DA-5262

Contract Amendment Number 2

PROJECT: LAX TERMINAL CORES & APM INTERFACE (DA-5262)

**RE: Terminal Cores and APM Interface DA-5262  
CCR 144 T5.5 NELA DAS - Change Directive 0033 (Revised)**

DEPARTURES LEVEL ENLARGED REFLECTED CEILING PLAN ZONE 9A  
 601 WORLD WAY LOS ANGELES, CA 90045  
 DATE: 04/22/2020  
 SCALE: 1/8" = 1'-0"  
 A03-20-6A

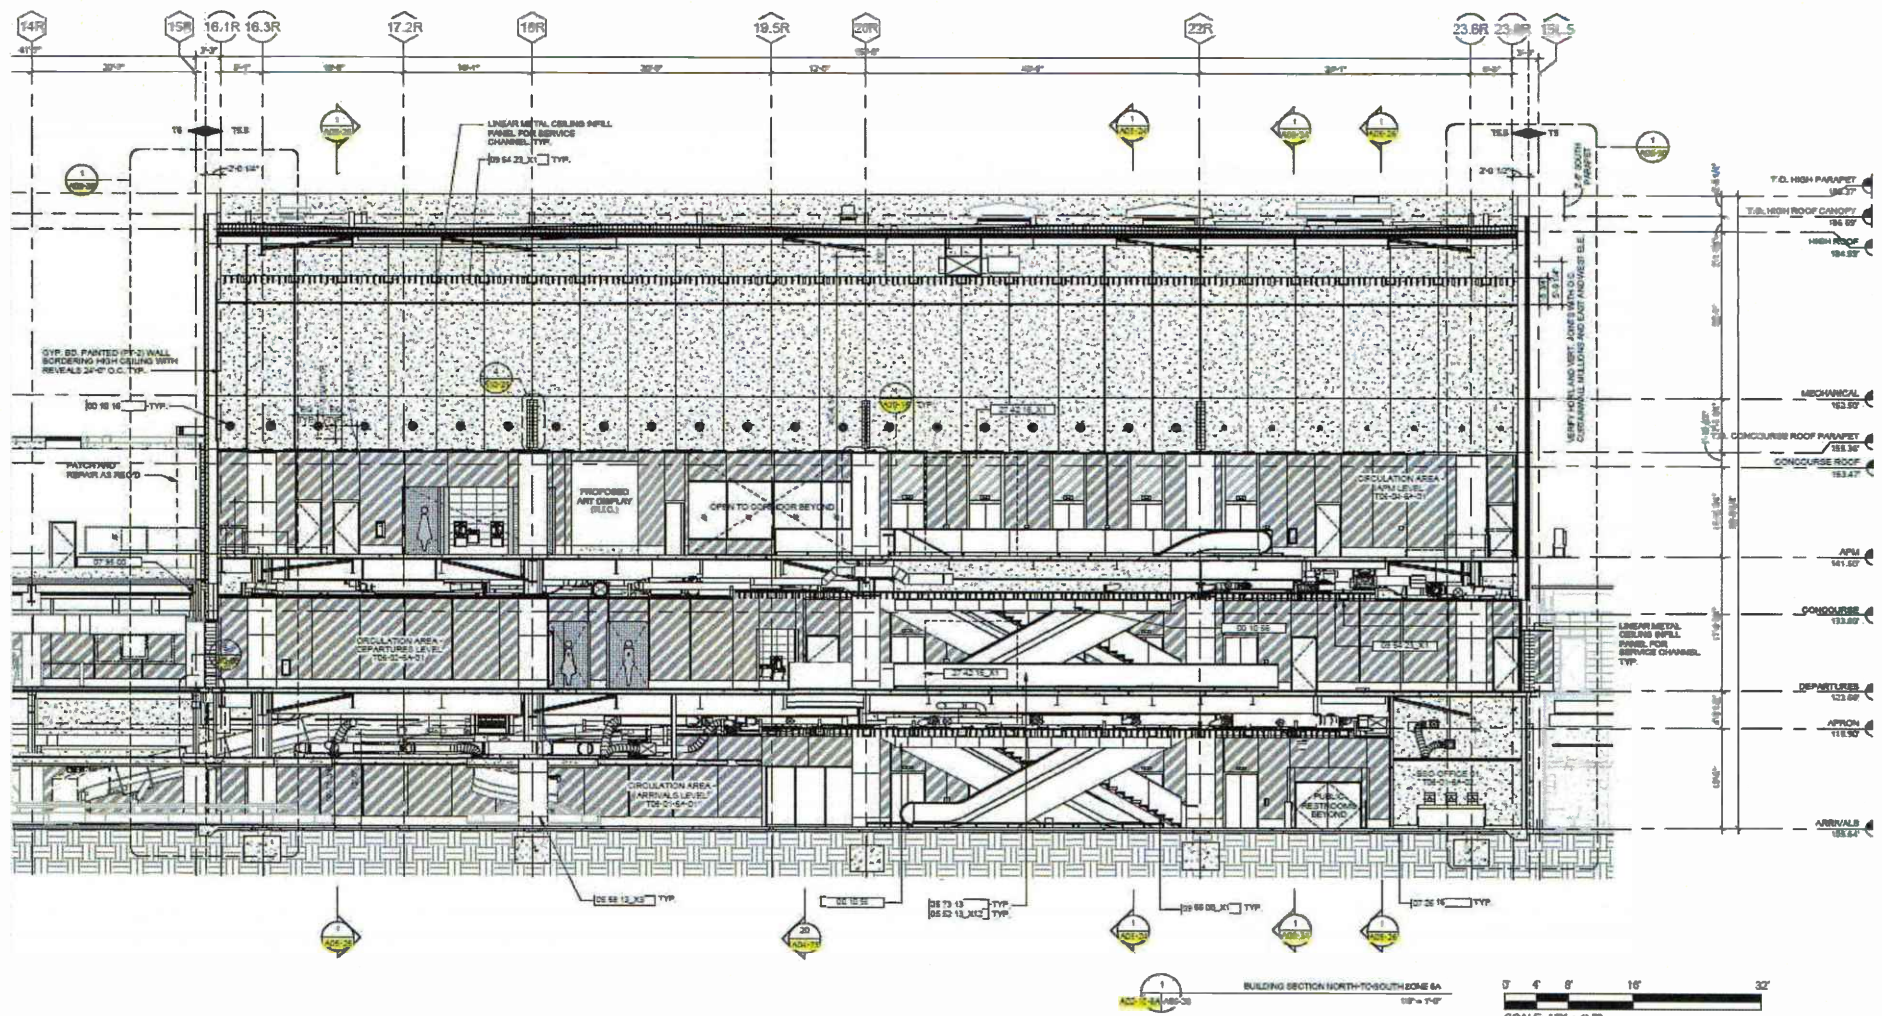
TO ANT347 & T5

TO ANT339

(1) 3" Sleeve Location TBD by T5.5 program team. See page 2 (S-B)

Riser location TBD by T5.5 program. See page 2 (R-1, R-2)

Riser location TBD by T5.5 program. See page 2 (R-3, R-4, R-5)

2" Sleeve at DMRU cabinet, this location. See page 2 (S-C)

Only curbside antennas shown here, indoor antenna & cabling by DAS GC

DMRU cabinet to be placed above tug lane, exterior to building & installed by DAS GC. See page 8 for details
